4a. Noise Levels and Methodology

This chapter shows that there are a number of flaws, inaccuracies and invalid assumptions in the noise predictions in the revised application. A noise level prediction method which lies outside ETSU-R-97, the government's approved methodology, has been used. This method does not have any official standing, has received negative peer-review and allows developers to underestimate the noise levels of the turbines at nearby properties. The applicant calls this 'best practice'. Some of the 40 dwellings within 1km of the site have been missed out of the assessment altogether. Of those which remain, only 10 are shown in the applicant's tables, giving the impression that not many properties will be affected. DTOG has put all missing properties back into the tables to show the real situation. Conflicting assessments for background noise levels and ground conditions are revealed. The applicant has been forced to model the turbines running in various degrees of noise-suppression mode (with lower power output as a consequence) in order to stay within predicted noise limits. Even then, predicted noise levels at a number of properties are either just below or ex

Figure 4a.1

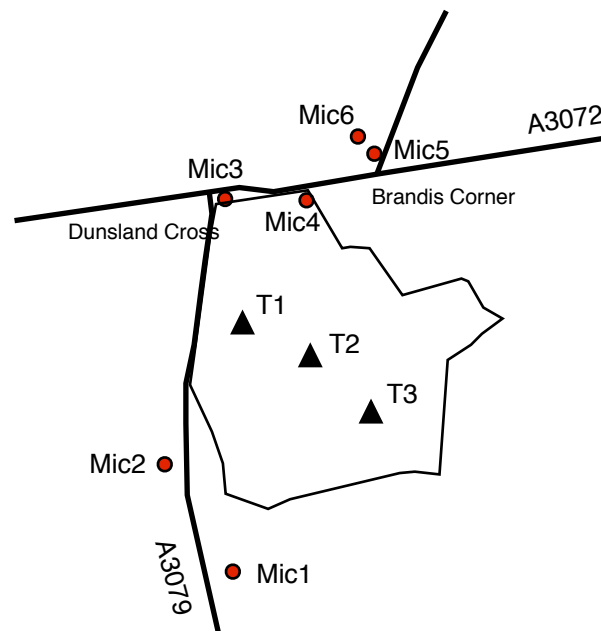
4a.4.7 As required in ETSU-R-97, background noise measurements were taken from locations near the site. A total of 6 microphones were in use from Tuesday, 19th October until Wednesday, 17th November, 2010. The microphone locations are shown in Figure 4a.1 below. Automatic rain gauges were located alongside microphones 2 and 5. The siting, setting-up and calibration of the microphones and rain gauges were overseen on that first day by Mr. Bob Davis (see paragraph 4a.1.4 above), who accompanied Mr. Neil Dodds, an in-house acoustician from Arcus, the company commissioned by the applicant to produce an ES which will persuade TDC to grant planning permission for this wind farm.

Fig 4a.2

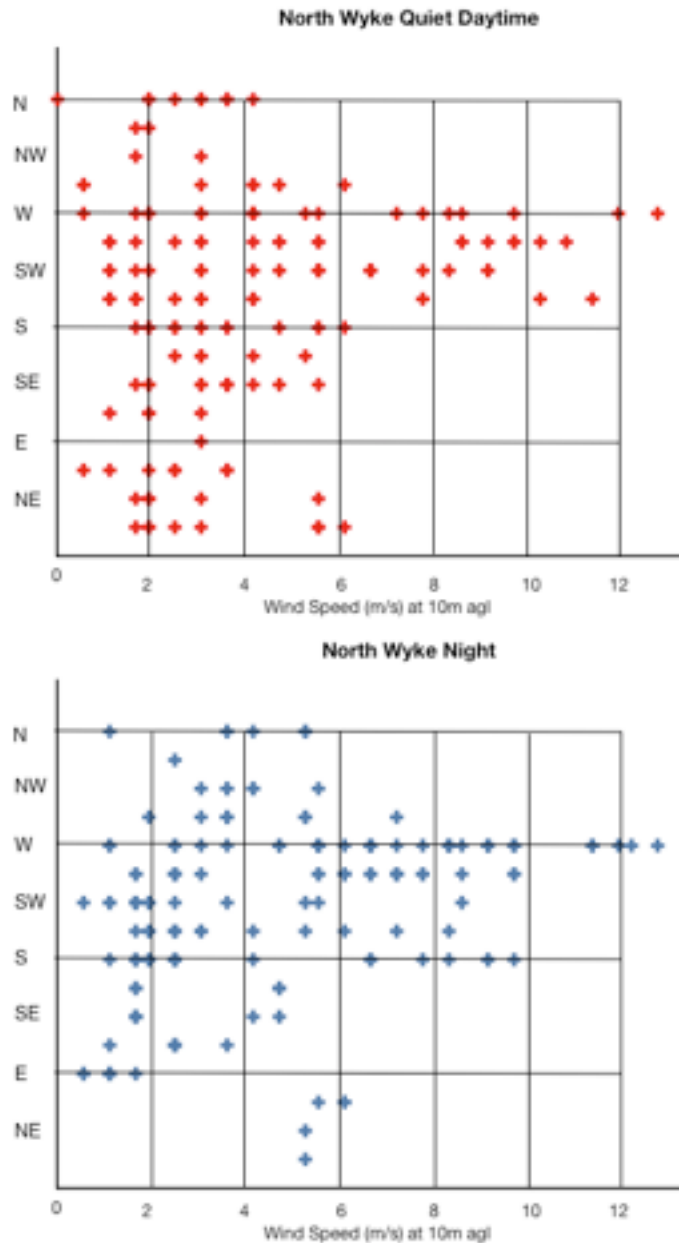
4a.4.17 Because this information is so important, DTOG has supplied it in Figure 4a.2 below. DTOG will be happy to supply TDC with the full set of readings used to create the graphs. The detailed rain event record is also available for this period.

4a.4.18 To produce Figure 4a.2 the readings were filtered to remove the non-quiet daytime periods and the remainder separated into quiet daytime and night time batches. The two graphs show the wind speeds and directions for these two time zones for the noise monitoring period:

4a.4.19 The critical areas of the graphs are wind speeds above 2.5 m/s at 10 m agl (giving a cut-in speed for wind turbines of approximately 3.5 m/s at hub-height). The turbines would reach their rated power and greatest noise at approximately 8 m/s at 10 m agl (approximately 12 m/s at hub-height). The blank areas show the data gaps. It can be seen clearly that the applicant is likely to have no data for wind speeds over 6 m/s for all directions from NW right round to S (daytime) and from NW right round to SE (night time). If the applicant does not accept that these graphs for North Wyke also represent the situation at Dunsland Cross then the actual equivalent graphs for Dunsland Cross must be produced to prove it.
